Docket Item # 22
BAR CASE # 2015-0269

BAR Meeting
September 16, 2015

ISSUE: New Construction: Building 3

LOCATION: 2 Duke Street

NORTH ELEVATION

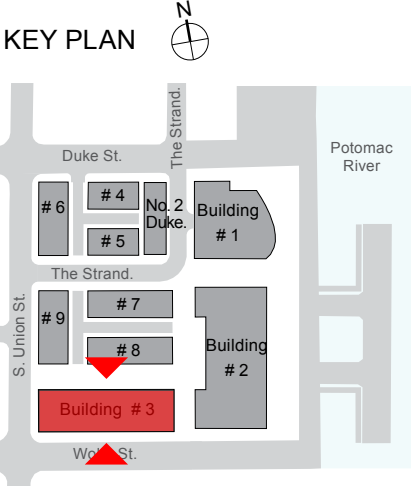
1. Make the hyphen between buildings 3 and 3A more distinct;
2. Continue to differentiate the eastern end of the building; and
3. Refine the stone work on the door surrounds on the north elevation

As the BAR noted at the last hearing, a fully expressed hyphen connecting the two elements of Building 3 will also distinguish the two building segments and provide additional visual interest. Carrying the dark grey slate color used on the fifth story of the western element down through the hyphen would visually recess the hyphen further and function as a break between the two building elements, suggesting the historic service alleys found throughout Old Town. The use of the dark grey color combined with large glass windows will make this hyphen a distinct element. The removal of the pronounced mullions could also visually mark this as a connector between the two elements while making the hyphen appear more transparent. It may, or may not, be necessary to carry this design idiom through on the north elevation of Building 3, where the break is less integral to the design.

ENTRANCE ELEVATION

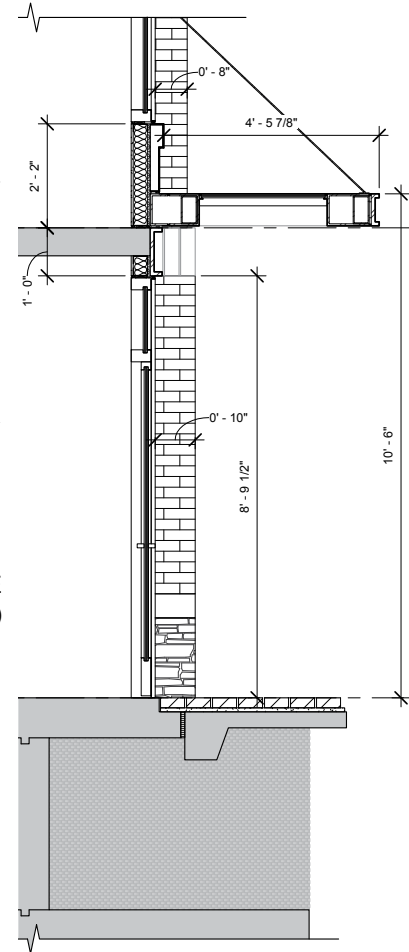
The applicant has proposed a mix of stone and brick for the pilasters and surround on the north elevation. However, the use of field stone, like one would see on a historic Alexandria building's foundation, is not appropriate for pilasters and an entrance surround. The use of stone, conceptually, is architecturally appropriate and identifies the importance of the entrance but staff recommends that the doorways be surrounded by a dressed and tooled, cut stone.
